SUBJECT: Forwards update to Chapter 14 of FSAR reflecting that util
 will perform preliminary testing. Responses provided to
 Benedict questions re personnel qualifications. Info will
 be provided in Amend 16 to FSAR.

November 9, 1984
(NMP2L 0231)

Re: Nine Mile Point Unit 2
Docket No. 50-410

Attached for your use and information is the update to Chapter 14 of the Final Safety Analysis Report. This submittal reflects the change in performance of preliminary testing, specifically the fact that Niagara Mohawk will be managing this effort. Additionally, we have provided responses to Mr. Benedict's recent questions regarding qualifications of personnel.

FIGURE 14.2-7

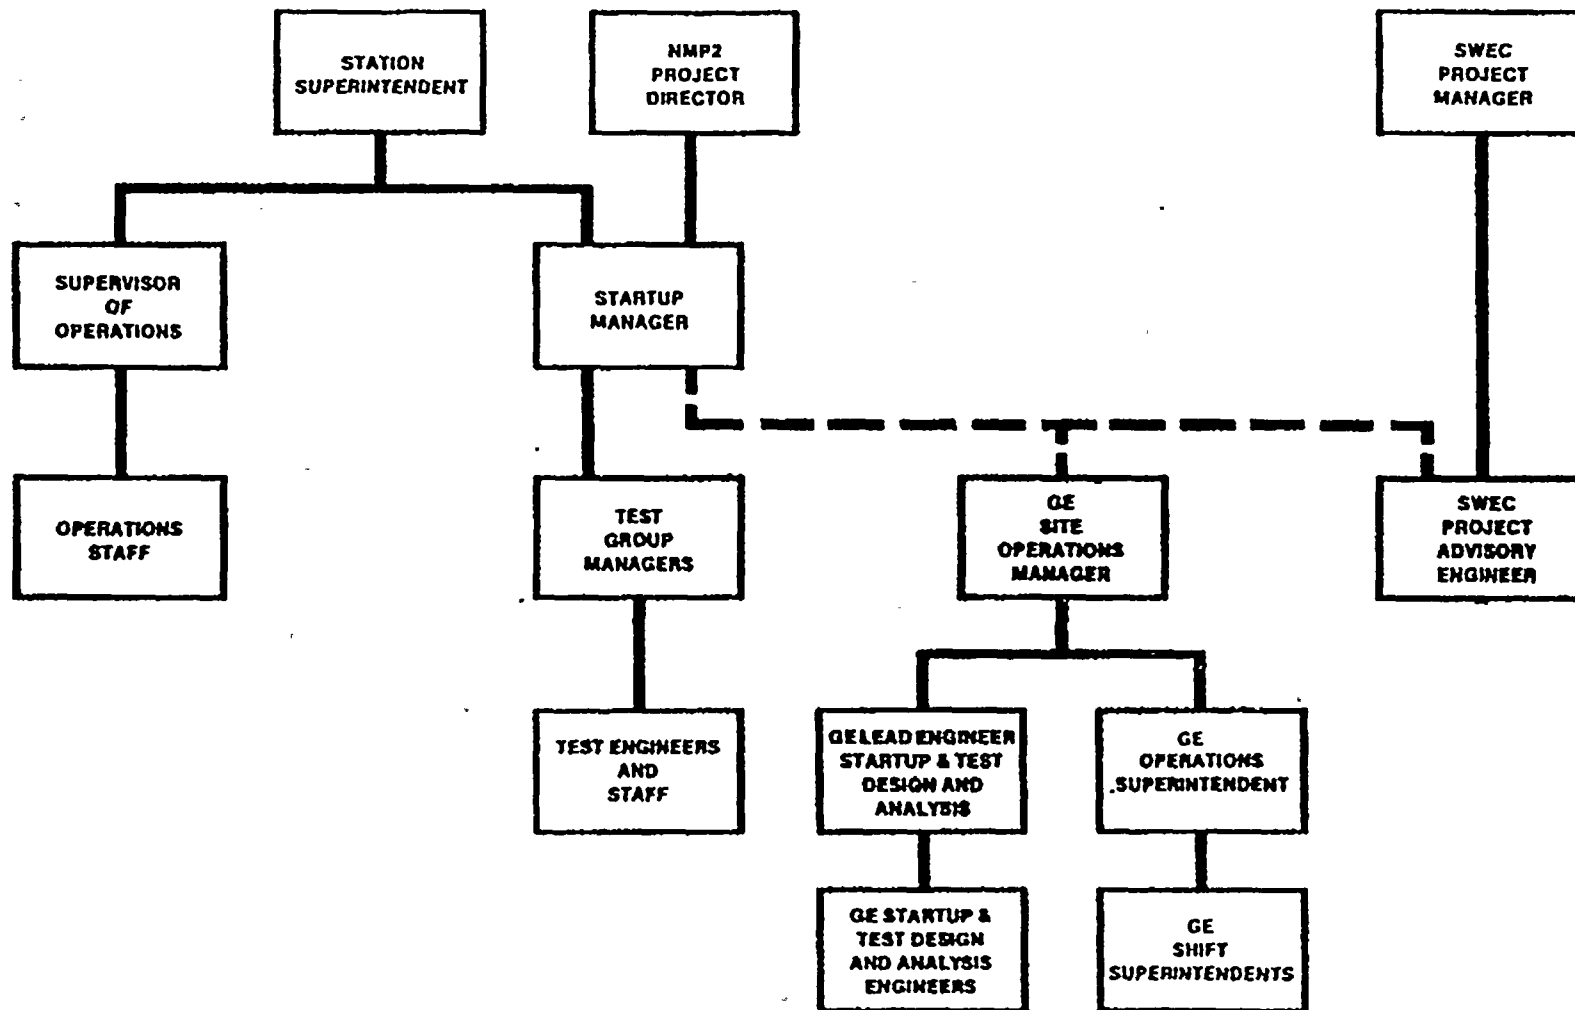
The Unit 2 organization for testing and interface between Niagara Mohawk, SWEC, and General Electric is shown in Figure 14.2-7 for the preoperational and preliminary testing phase and startup and testing.

The test group consists of the Startup Manager, Test Group Managers, Test Engineers, and technical staff as required (Figure 14.2-7). The operations group includes the Supervisor of Operations, Assistant Supervisor of Operations, Station Shift Supervisors, Assistant Station Shift Supervisors, and operators, as discussed in Chapter 14 (Figure 14.2-7).
